Subject: RE: Dungeness Reservoir - Seismic Reconnaissance

Geotech Feedback on Seismic Questions

Subject: Dungeness Reservoir - Seismic Reconnaissance

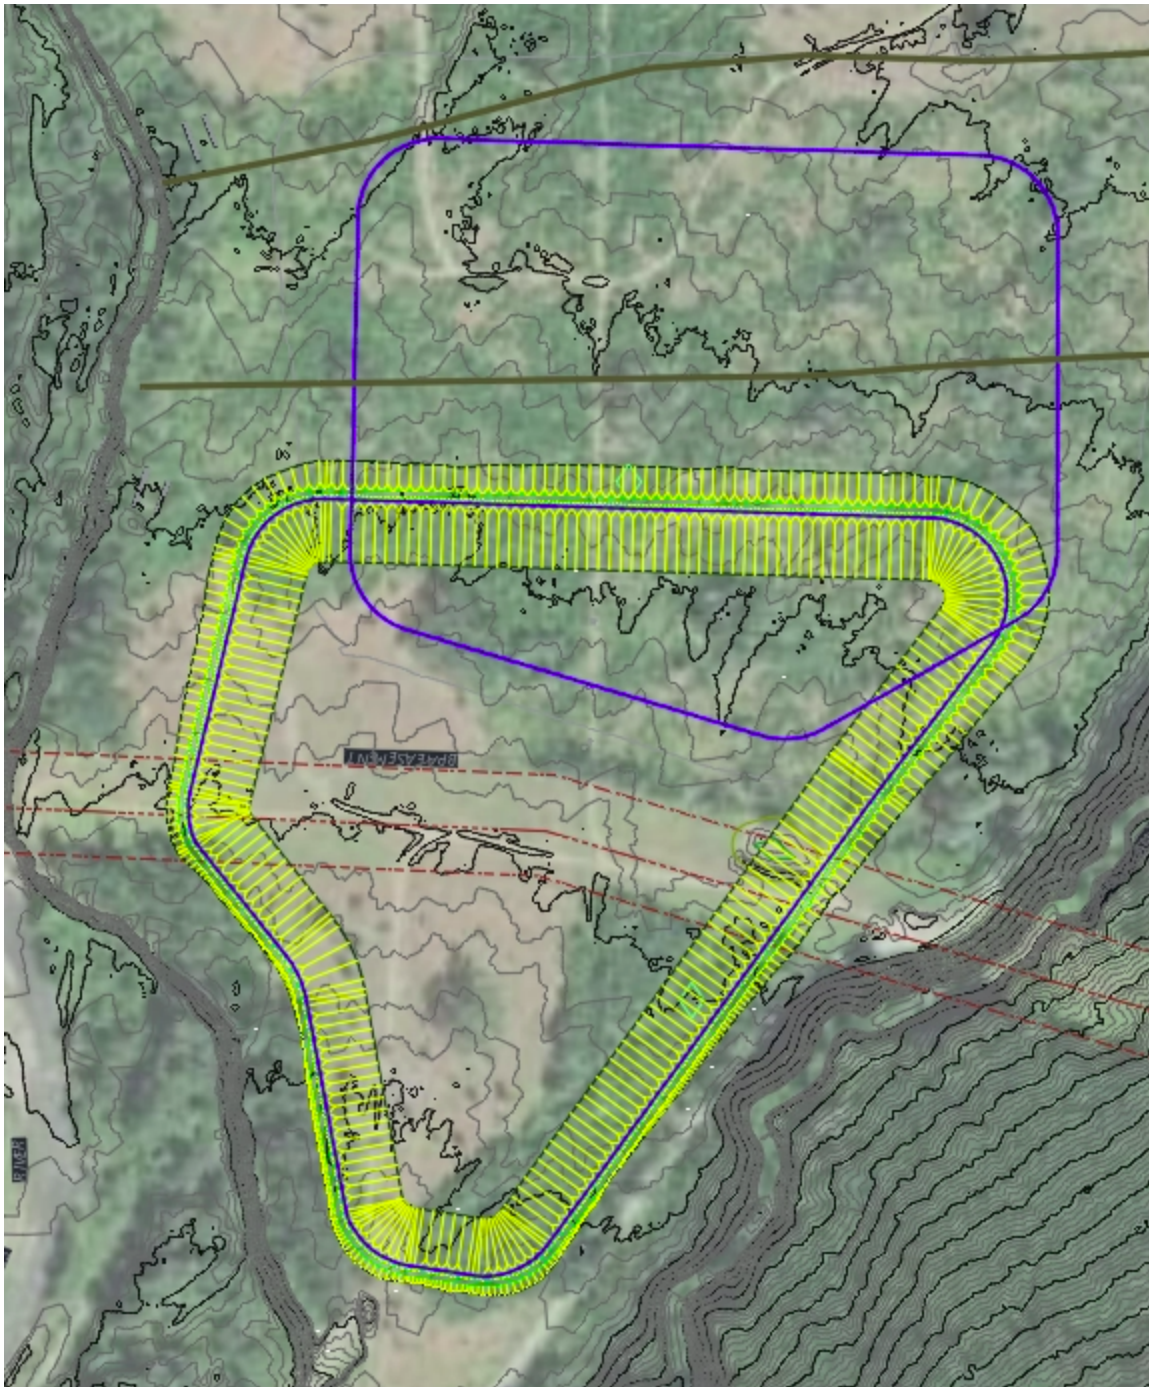
We took an initial look at this by modeling a reservoir in AutoCAD Civil 3D with the reservoir completely south of the furthest south potential fault line that was mapped by Shannon & Wilson's geologist, Chris. The clip below shows the outcome of this exercise. The yellow represents the embankment, but does not include the toe berm (that would need to be added through refinement). The blue line over the yellow area represents the full water surface. The other blue line represents the full water surface of the reservoir included in our preliminary design. Here are a few things to note:

- The volume of the reservoir modeled was just under 1,700 acre-feet. So, we could refine it a little to reduce the volume to 1,600 acre-feet.
- We kept the top of the embankment at 438 feet and the full water surface elevation at 435 feet, which are equal to the numbers we used for preliminary design.

- We also kept the bottom of the reservoir at a similar elevation to what was included in the preliminary design.
- The embankment height and extent are smaller than what we had in the preliminary design because the ground elevation is higher toward the south end of the site. The ground elevation is about 10-12 feet higher at the north end of the reservoir under this configuration than for the preliminary design configuration, which means that the embankment would be about 10-12 feet shorter.

- The excavation volume would be greater than the excavation required for the preliminary design configuration. We have not refined this enough to look at costs yet, but given the trend we've seen with the other configurations we've looked at, I would anticipate the cost to be greater based on the increased excavation volume.

- This configuration does not consider the BPA easement or infrastructure as a constraint. We would need to confirm with BPA whether this was even possible or not. They may have limited ability to restrict what we do on the property their infrastructure crosses if it is truly an easement and not a right-of-way or fee-owned property. We reviewed the documents we have on file for the BPA easement. Based on our read, we think the property is an easement rather than a right-of-way or fee-owned property. Their documents refer to the corridor on which their infrastructure is built as either easements or fee-owned properties, but they refer to both of them as right-of-way, which is kind of confusing. In this case, based on the descriptions provided, we believe their infrastructure is on an easement through the reservoir property. They would likely still require access to their infrastructure for maintenance. There are at least two sets of power poles within the footprint of the reservoir shown in this configuration. Those would probably need to be protected or replaced. So, there would definitely be some work to do to confirm what could and couldn't be done through their easement and the reservoir would need to be configured to meet those constraints, which could reduce the footprint and volume.

- The configuration does not consider the Type 1 Wetland found in the pit near the entrance to the site as a constraint. The impact to that wetland should be something we can mitigate. I'm not sure what the mitigation would look like, but I don't think it would be a big deal.

- We tried to maintain space between the reservoir and the shoreline buffer and between the reservoir and the road to the east.
- I believe most of the cleanup site is still south of the reservoir footprint in this configuration.
